STAFF REPORT: NOVEMBER12, 2025 REGULAR MEETING

APPLICATION NUMBER: HDC2025-00589

ADDRESS: 2585-2603 W. GRAND BOULEVARD (MARTIN LUTHER KING JR PARK)

SCOPE: EXPAND, ALTER, AND REHABILITATE PARK

Demolition Plan (within the park's current footprint), submitted by applicant. Dark hashed area indicated concrete and brick pavers proposed for removal. Light hashed areas show trees proposed for removal.

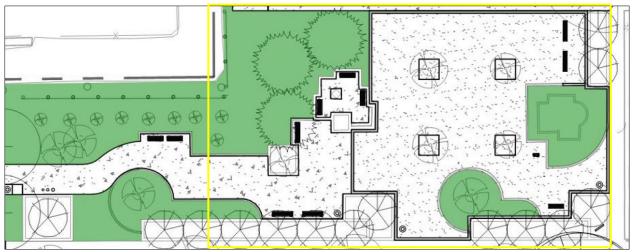
- The footprint of the park's walking surface will remain the same. However, the design and materials of the surfacing will change, including the floor of the sculptural platform.
 - The removal of the aggregate concrete, brick pavers, and brick edging will eliminate the intentionally designed pathways through the park and the sense of spatial movement between landscape and hardscape elements, all of which combine to be a distinctive-character-defining feature of the park.
 - The coloring, pattern and surface texture of the brick pavers on the sculptural platform floor offset the monolithic gray and solid massing of the surrounding concrete walls and stairs. The verticality of the pedestal, in contrast with the deep red tiles, is pronounced; befitting its supporting role for the MLK Jr. bust.
- Brick edging will remain at the water fountain and two rounded/oblong landscape beds.

- Staff counted the number of trees proposed for removal in the demolition plan as well as the number of new trees within the proposed site plan; the reduction is from 42 to 25.

- The historic and existing (although sparse) linear arrangement of trees at the north and east boundary mirrors the linear arrangement of trees (within planters) at the western boundary. The proposed tree placement on the outer edges of the park appear to be compatible with existing conditions and in keeping with the original design.

- Conversely, the historic tree arrangement within the central space between the fountain and sculpture platform, is dense. The original plan included 11 grated trees; the current grate openings are 10 (with nine having trees). The proposed tree count at this area is four. The loss of so many trees will disrupt the organic flow of this space and the strong landscape connection placed between the organic forms of the water fountain and sculpture platform.

Proposed Site Plan, proposed changes to the existing Martin Luther King Jr. Memorial Park

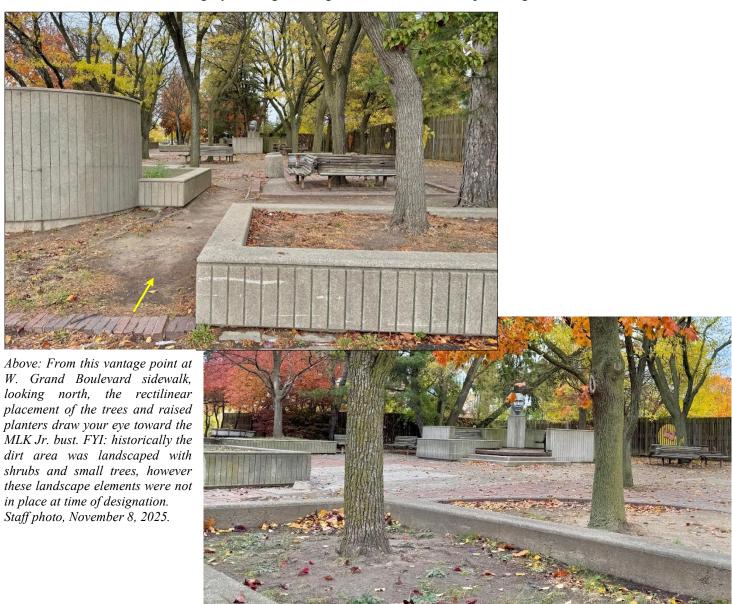
- The landscape areas, denoted in green on the proposed site plan, match the areas on the historic plan, but no further detailing is included.
- The applicant stated in a reply to staff that "Planting beds will have 'to be determined' planting material most likely a ground-cover. Green spaces = both lawn and plant bed areas."
- Staff notes that any proposed landscaping must be submitted to HDC staff for review/approval prior to planting.

- The proposed design removes many of the distinctive character-defining features of the park, including but not limited to:
 - Ground materials integrated design of concrete and brick tiles and brick edging. They are not deteriorated beyond repair, and the applicant did not offer an assessment for the repair, or in-kind replacement of the broken or missing brick pavers and brick edging, which is required by Standard Six. It has not been demonstrated to staff that the existing path surfaces can't be retained in conjunction with the park's expansion to the east and north. The brick edging offers a highly visible dimensionality and cohesive materiality for the landscape beds.
 - The reduction and symmetrical alignment of the trees between the fountain and sculpture create an openness that is incompatible with the holistic design of the park.

- New materials/components for the park are not compatible with the park's specific and distinctive modernist design:
 - Crushed limestone and concrete (devoid of any decorative/dimensional qualities) are not compatible replacements for the multiple smooth-faced walking surfaces that reinforce the geometry and pathways that link the park's sculptural forms.

- The installation of early 20th century-style lamp posts is not consistent with the integrated design of the park and could potentially create a false sense of historical development. The applicant should consider a design similar to the original lights, as was done for the selected wood benches and concrete aggregate drinking fountain.
- Additional information is needed:
 - The landscaped beds, and the plantings within them, are integral features of the park and originally reinforced the geometry and spatial relationships of the park's overall design. A fully detailed landscape plan is necessary to confirm if the proposed treatment is compatible with the historic features of the park.

Above: Applicant plan, new work in red. Right: Applicant cut sheet of trellis.

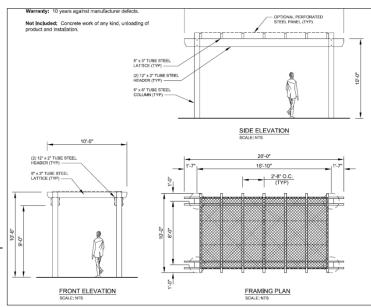
The design for the new park on the empty lots to the east of the historic park is designed as a gathering space with minimal activity/structures. The abundance of open greenspace will be anchored by a steel trellis at the east and west end of the lawn. The trellis' minimal ornamentation and steel finish create focal points that do not overpower or compete with the architectural concrete planters and structures within the historic park.

This view from the SW corner of the park, looking northeast, shows the existing wood fence that will be removed to join the new park space with the existing historic park. Staff photo, October 15, 2025.

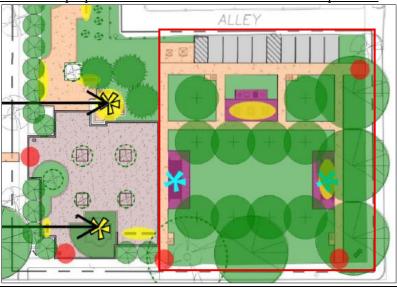
- A privacy fence currently runs the eastern property line of the historic park and is an element of the original/historic park plan. The wood panel fence is a utilitarian design and was installed to enclose the park from the then-existing adjacent structure(s) and alley. It is not a character-defining feature and can be removed as proposed in this application.
- In addition to the removal of the fence, the application proposes to remove the brick edging enclosing the historic park's existing eastern landscape bed and expand the crushed limestone park surface to the edge of the property.
- The brick edging and landscape bed are distinctive features. Their removal will alter the features and spaces of the site.
